Section 1

Introduction

This document responds to comments on the Draft EIR that were raised during the public review period, and contains revisions intended to correct, clarify, and amplify the Draft EIR. The responses and revisions in this document substantiate and confirm the analyses contained in the Draft EIR. No new substantial environmental impact and no increase in the severity of an earlier identified impact have surfaced in responding to comments. Together, the previously released Draft EIR and this “Responses to Comments” document constitute the Final Environmental Impact Report (Final EIR). As the lead agency, BART must certify the Final EIR before action can be taken on the Proposed Project. Certification requires that the lead agency make findings that the Final EIR complies with CEQA.

1.5 REVISED MEDIAN STATION EAST

REVISED MEDIAN STATION EAST OPTION AREA AND CONCEPTUAL PLAN
FIGURE 1-1

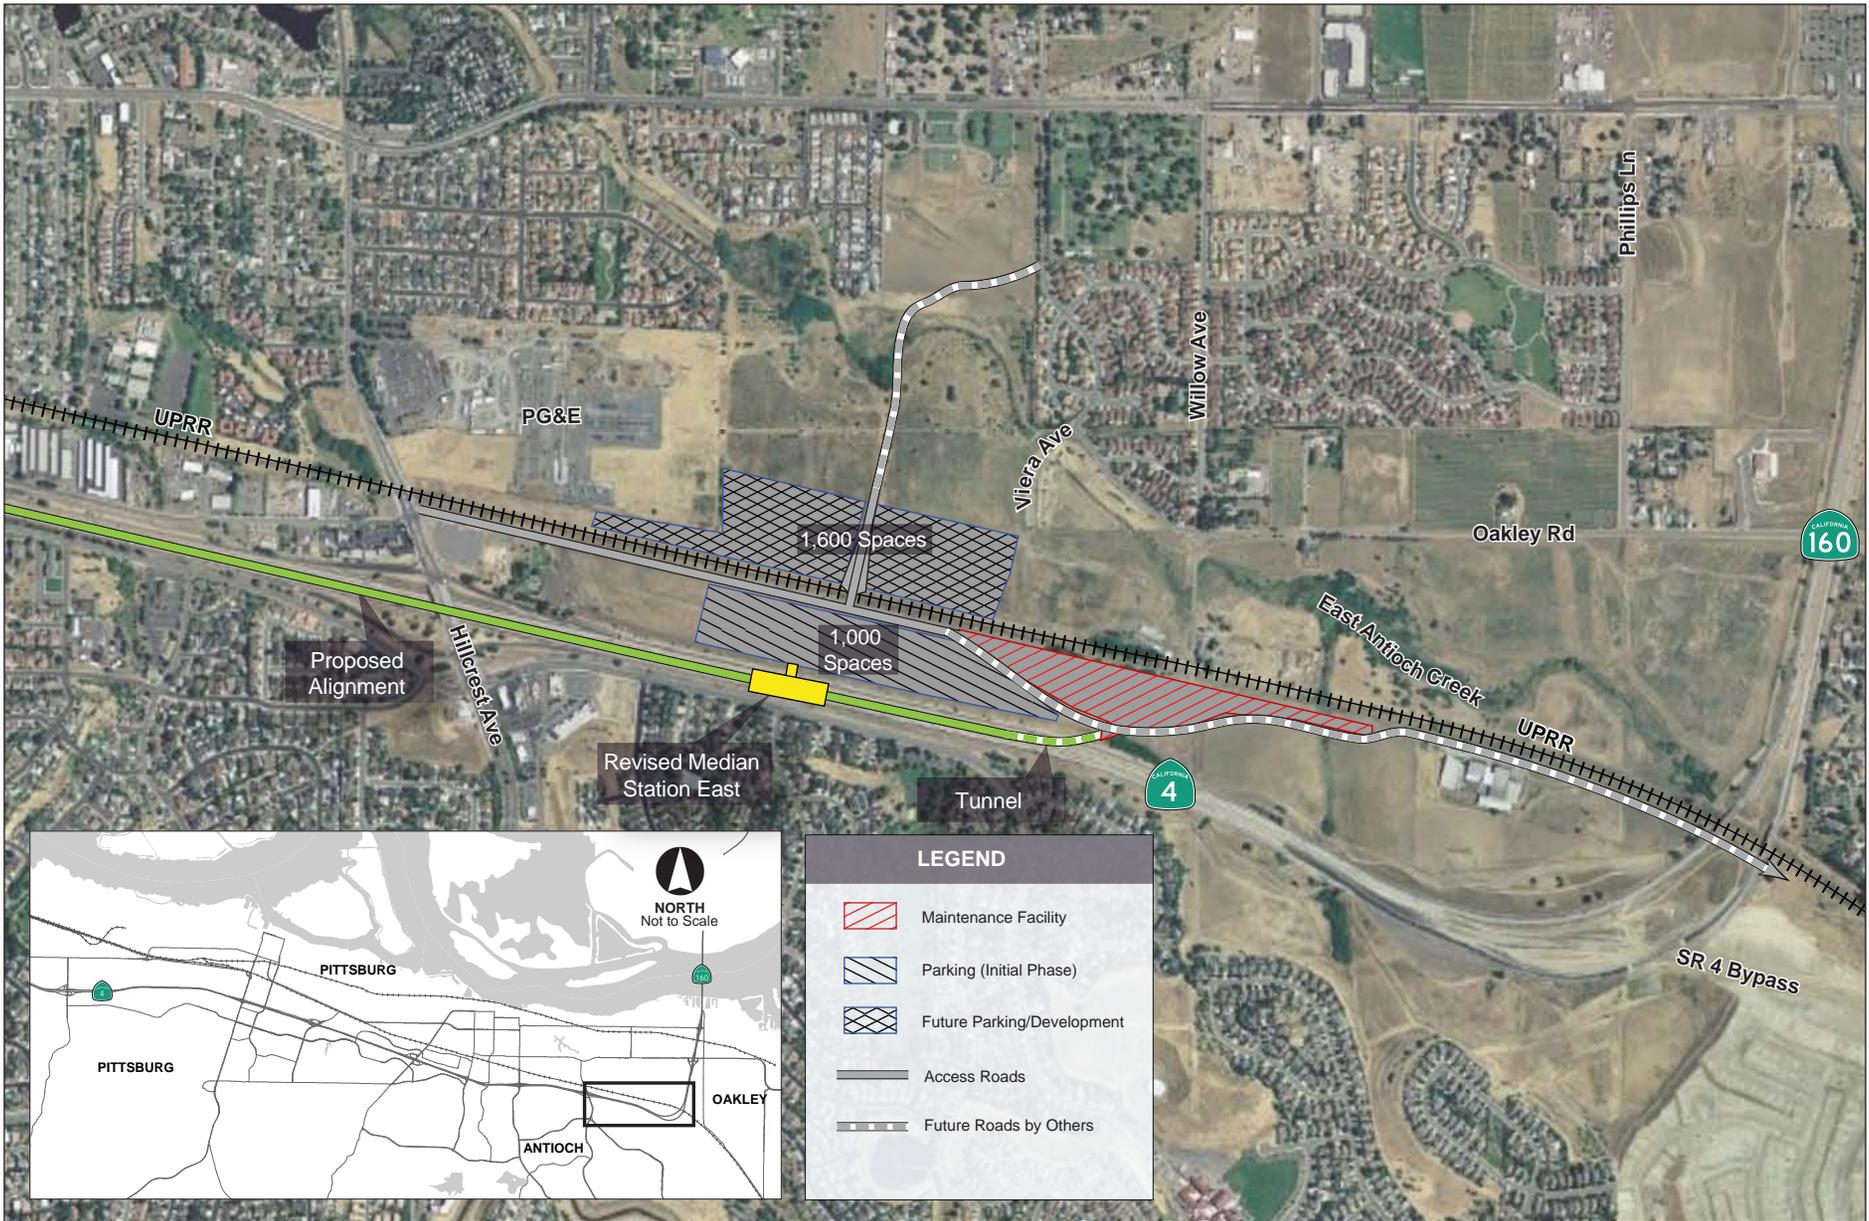
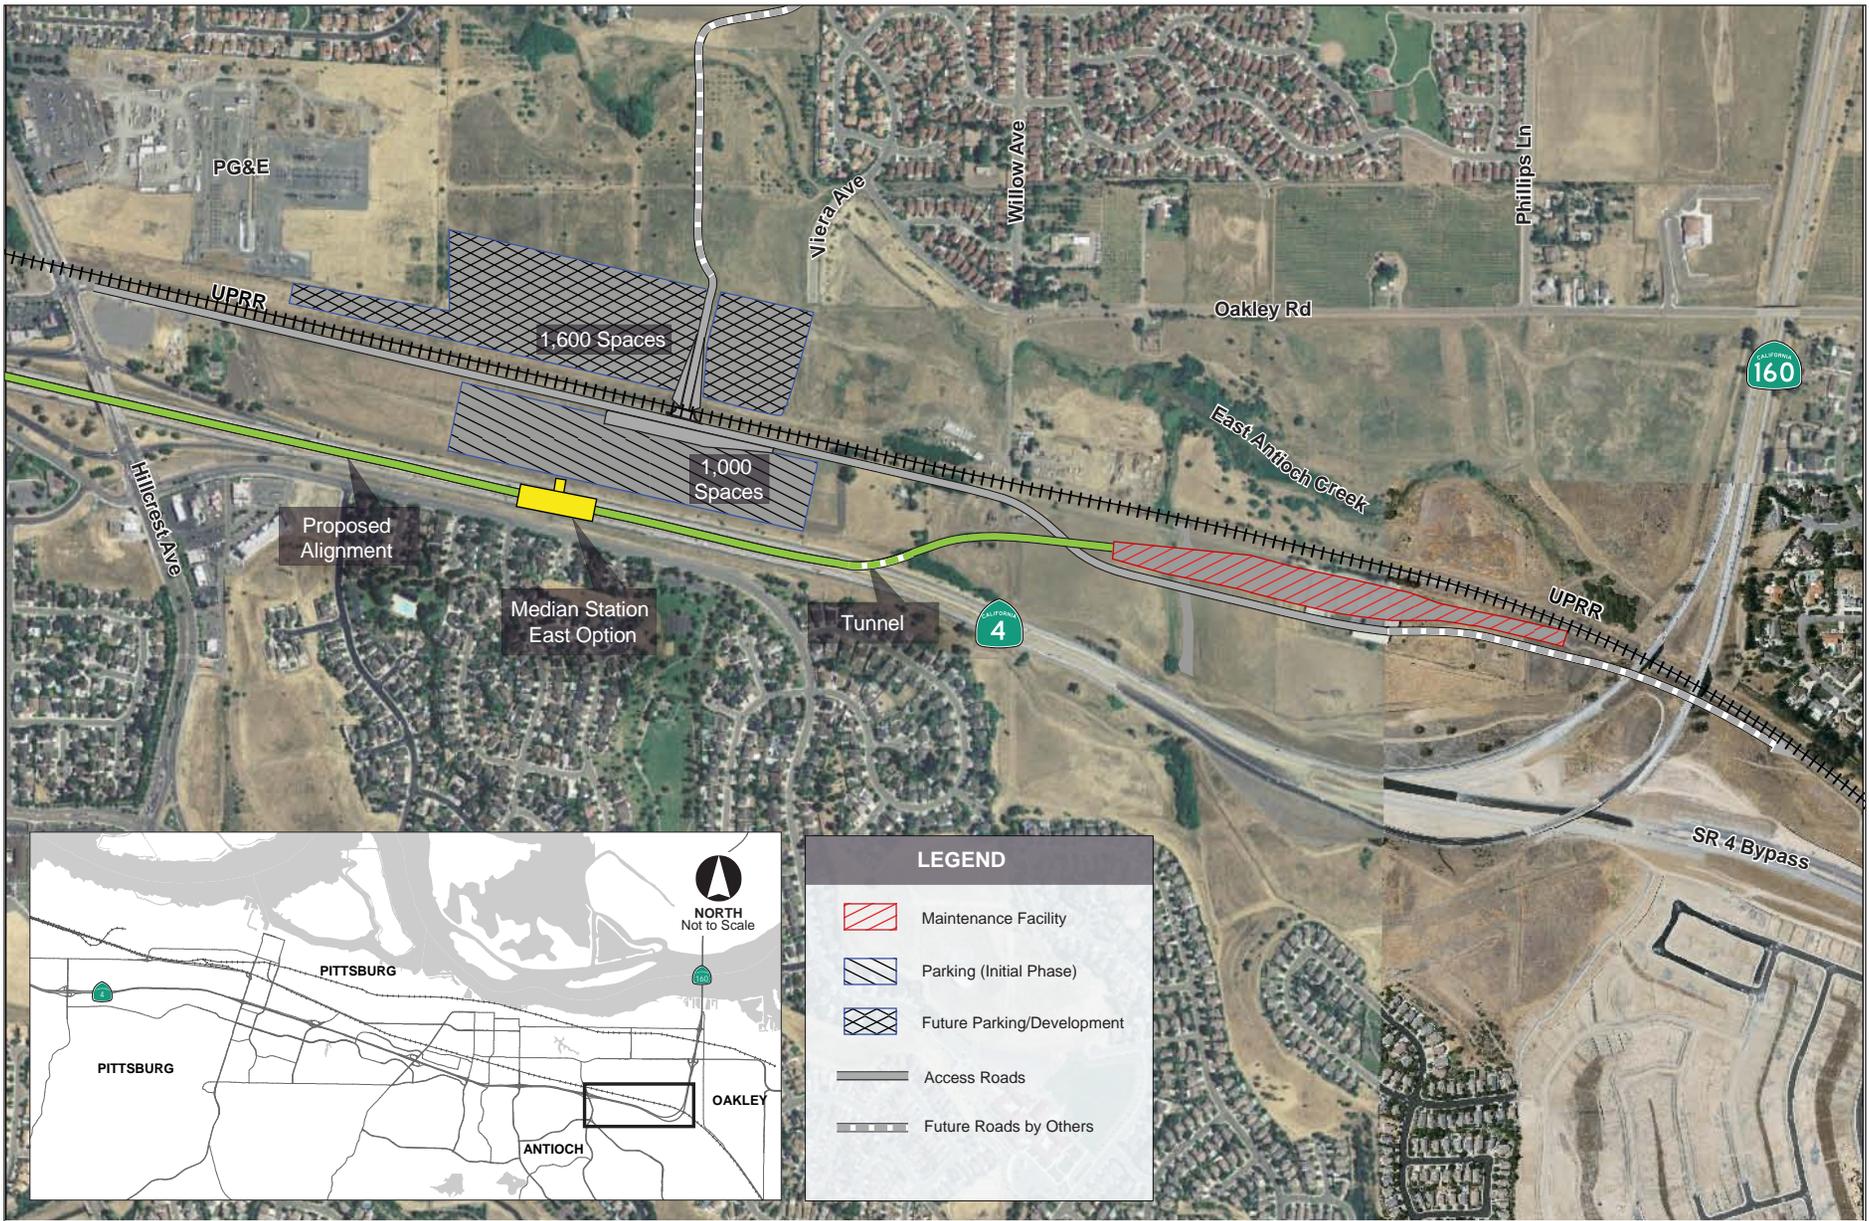
Based on ongoing discussions with the City of Antioch, BART has made revisions to the site plan for the eBART Median Station East option to make it consistent with the City's Hillcrest Station Area Specific Plan, prepared as part of the City's Ridership Development Plan process. The Revised Median Station East, illustrated in Figure 1-1, has three key features that differ from the original Median Station East option in the Draft EIR (reproduced here as Figure 1-2):

- 1) **Location of Station Platform.** The station platform in the median of SR 4 has been moved approximately 200 feet to the west, which allows for additional tailtrack area east of the station platform.

- 2) **Location of Maintenance Facility.** The DMU maintenance facility has been relocated from a point near the Northside East Station site (and Phillips Lane extension) to a more westerly location south of the Union Pacific Railroad (UPRR) line and adjacent to the eBART parking area.
- 3) **Alignment of Sunset Drive/Slatten Ranch Road.** Rather than following an alignment just south of the UPRR right-of-way, the eBART access road to serve the station and maintenance facility curves to the south after passing the east end of the parking lot, where it then follows an alignment along SR 4.

The purpose of these revisions was to shift the eBART facilities between SR 4 and the UPRR to the west and to provide additional land for transit-oriented development and the associated economic benefits for the City. These revisions would preserve the opportunity to construct the Northside East Station at a future time.
